PETERSBURG HARBOR REHABILITATION

PROJECT No. 69719

AS BUILT

69719
PETERSBURG
NORTH HARBOR
KUPREANOF &
PAPKE LANDING
REPAIRS
Sht 1 of 10

STATE OF ALASKA
 DEPARTMENT OF TRANSPORTATION AND PUBLIC FACILITIES
 PETERSBURG, North Harbor ALASKA
END TEE FLOAT REPLACEMENT & WALKWAY REPAIRS

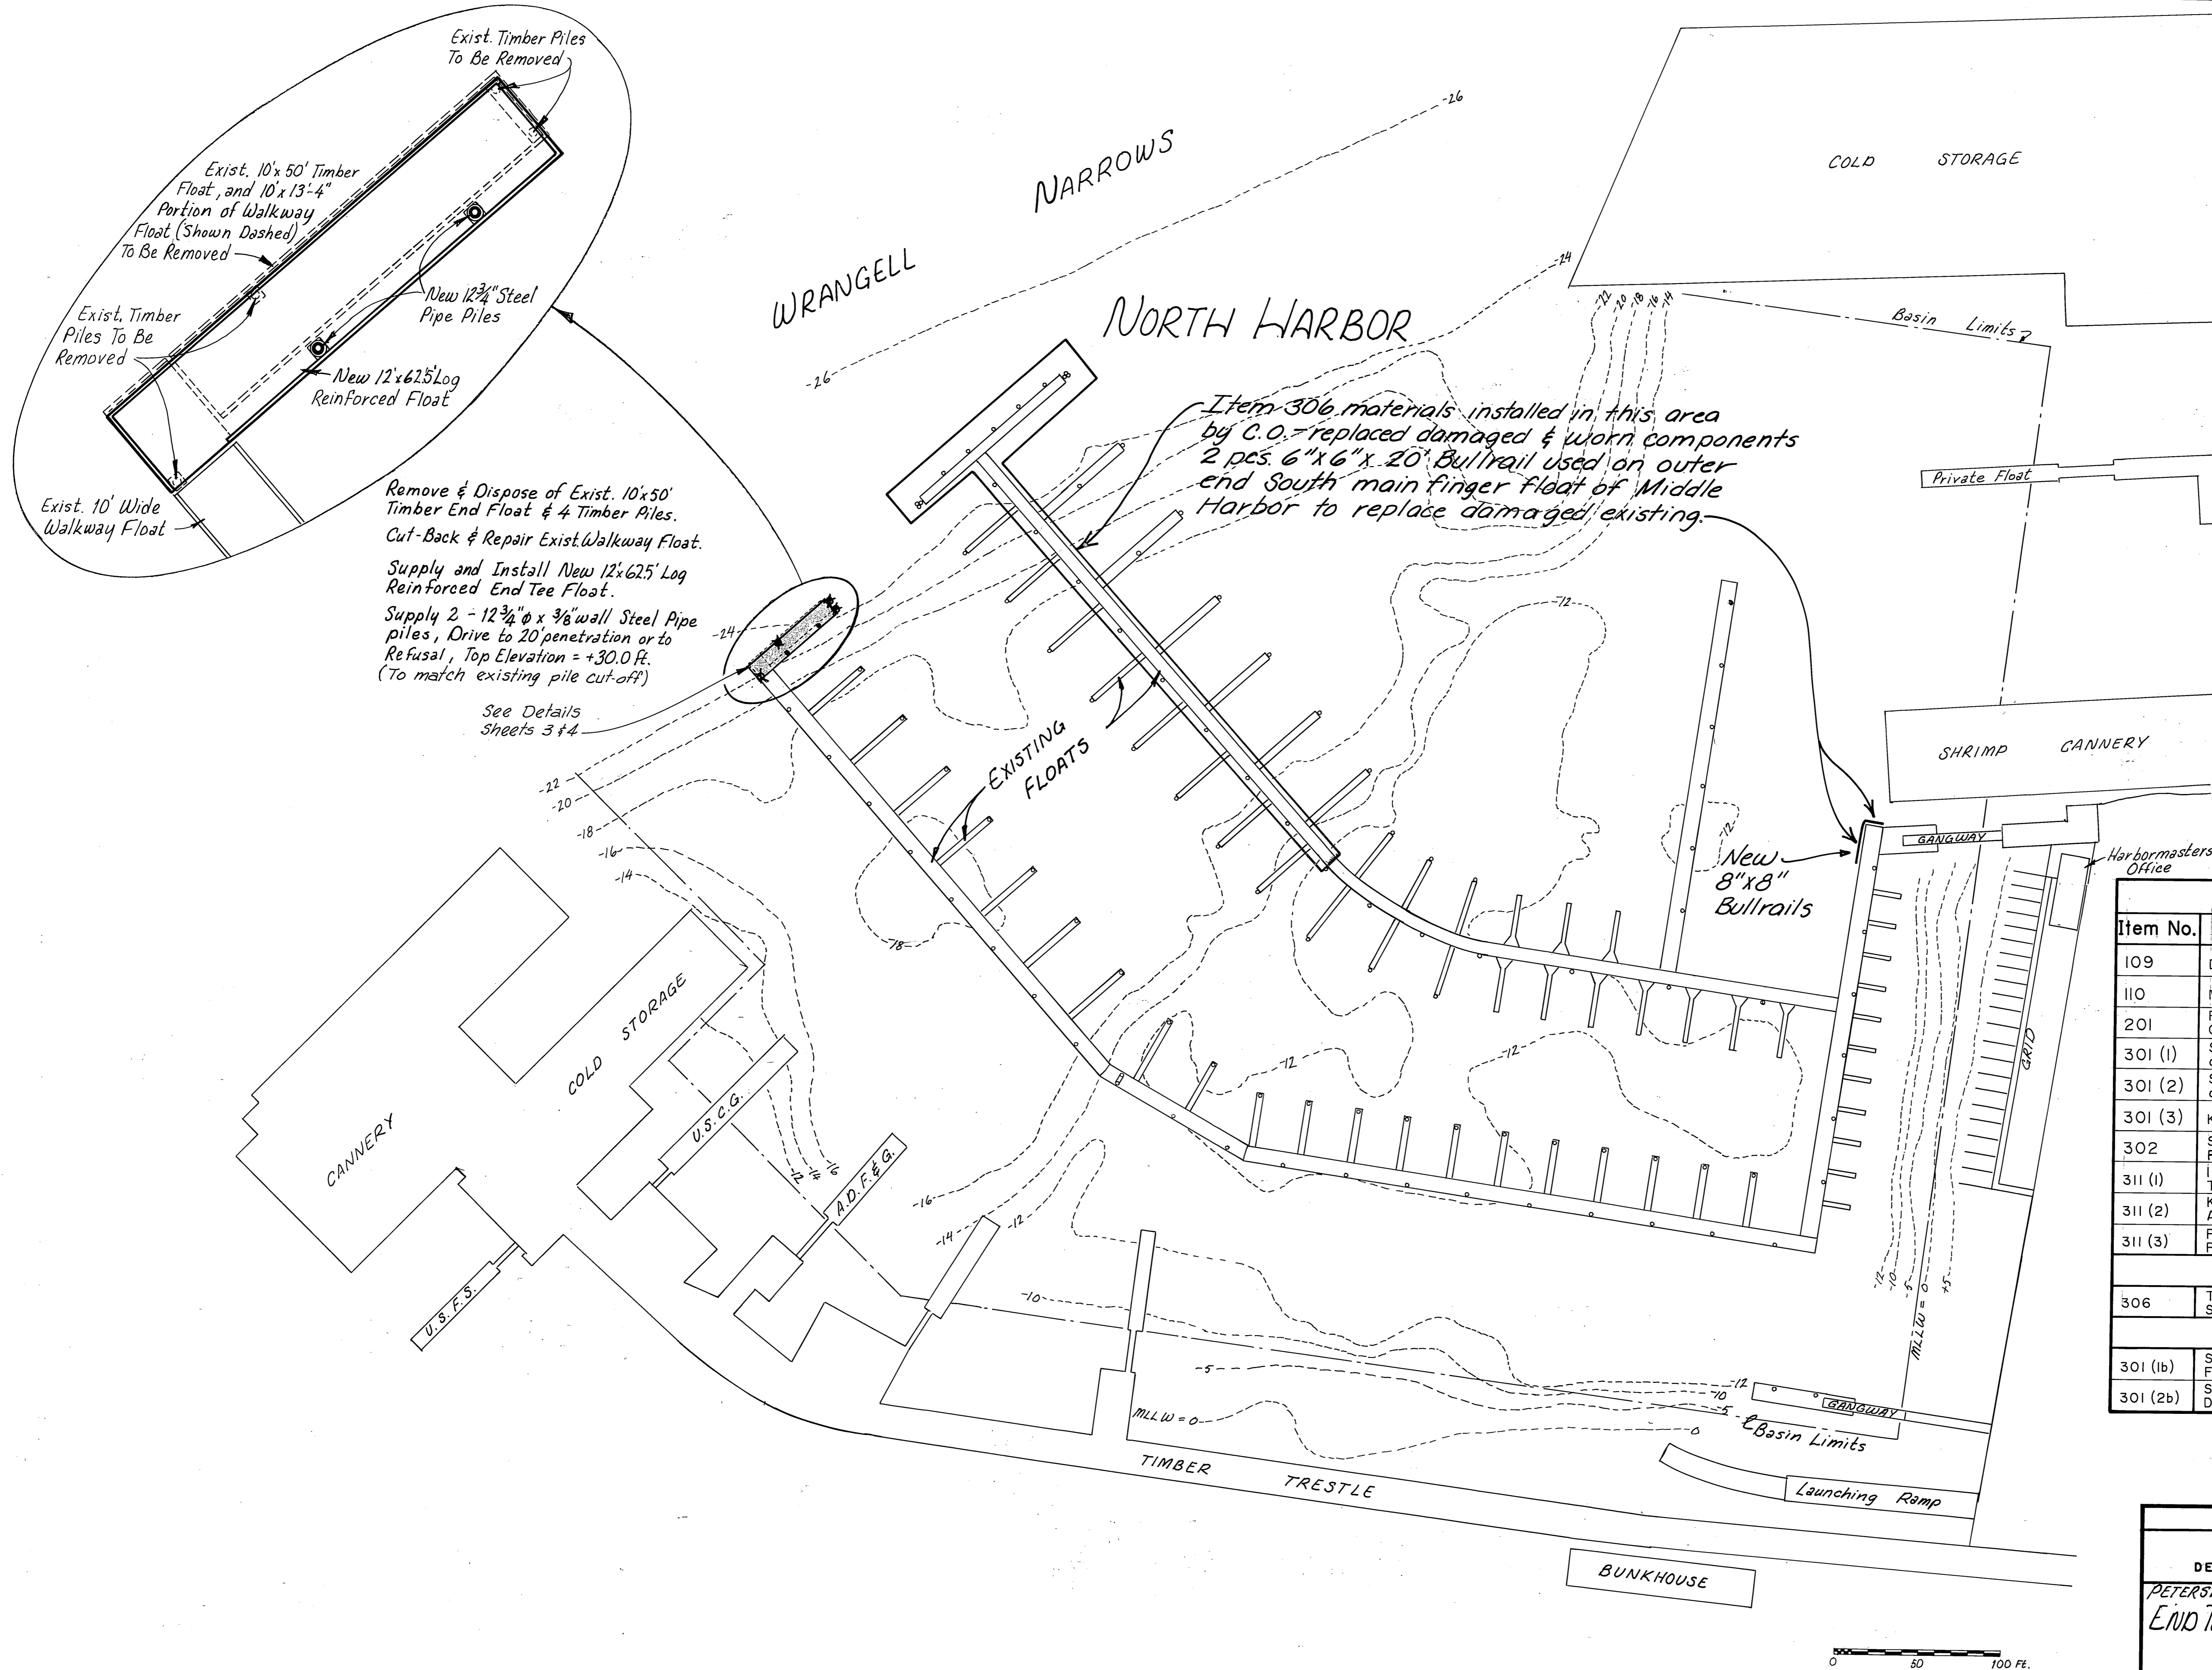
Item 306 materials installed in this area by C.O. - replaced damaged & worn components 2 pcs. 6"x6"x20' Bullrail used on outer end South main finger float of Middle Harbor to replace damaged existing.

TIMBER APPROACH REPAIR DIAGRAM

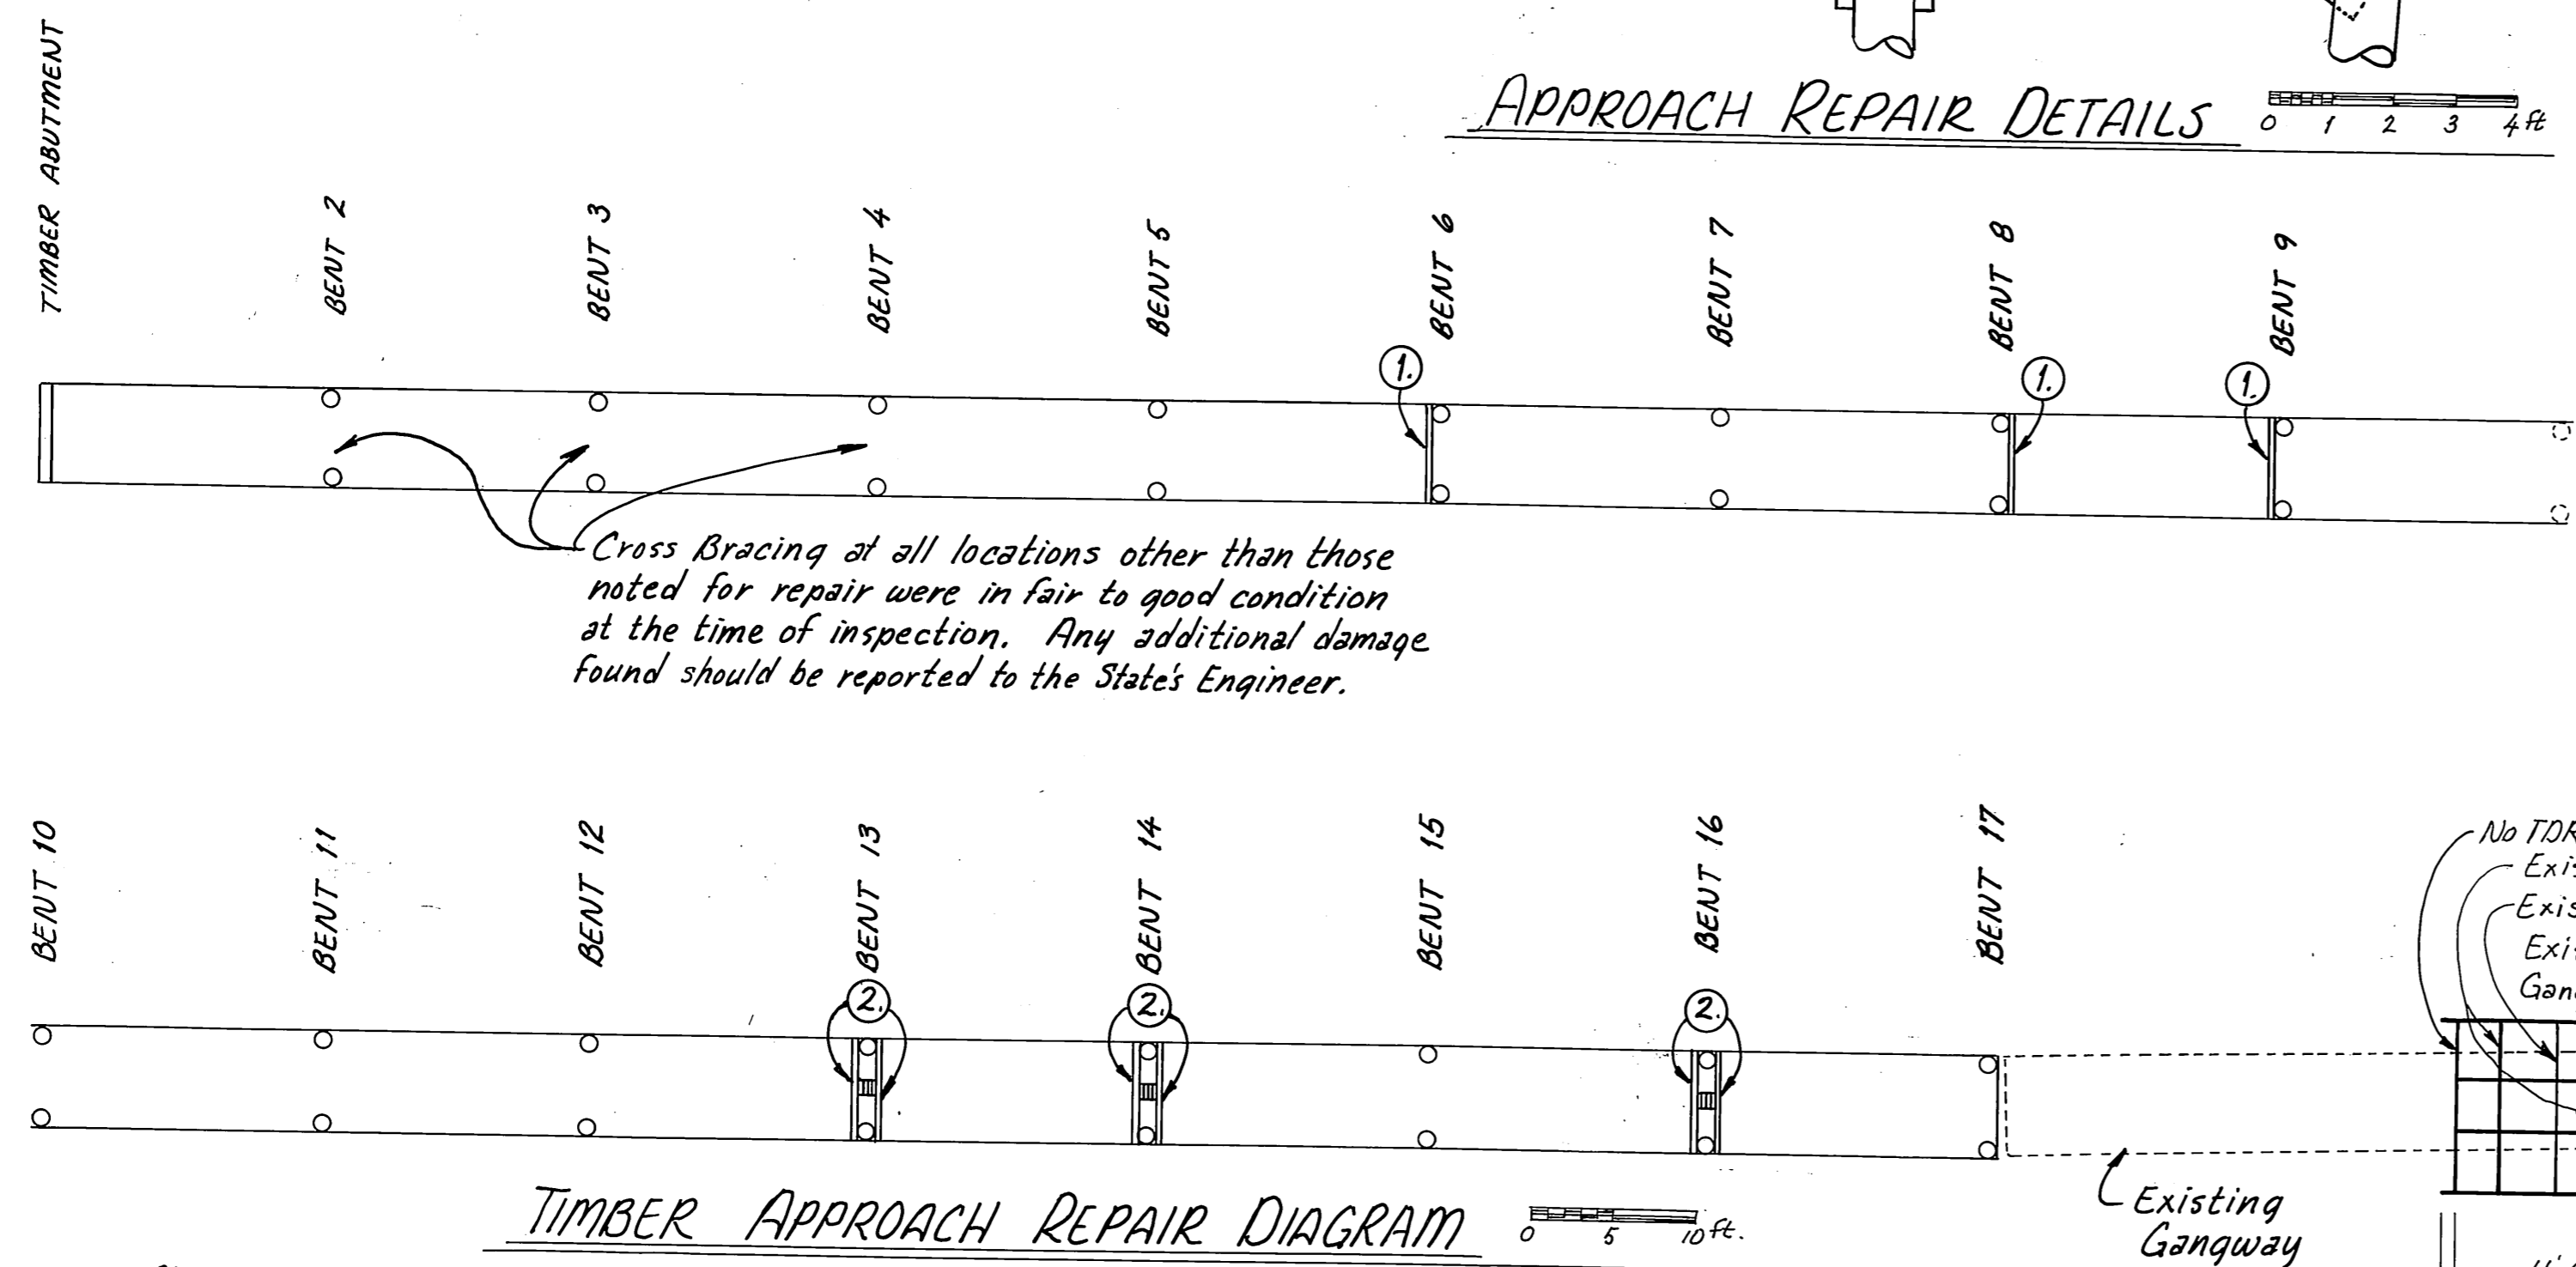
This vertical pile originally driven to far N.E. in collar - was plumbed at half tide & Dolphin Framed, but on minus tide, float forced pile over causing top blocking to shift & tilt - Tilt cannot increase further as float goes aground on big minus tide - Dolphin is functional as is
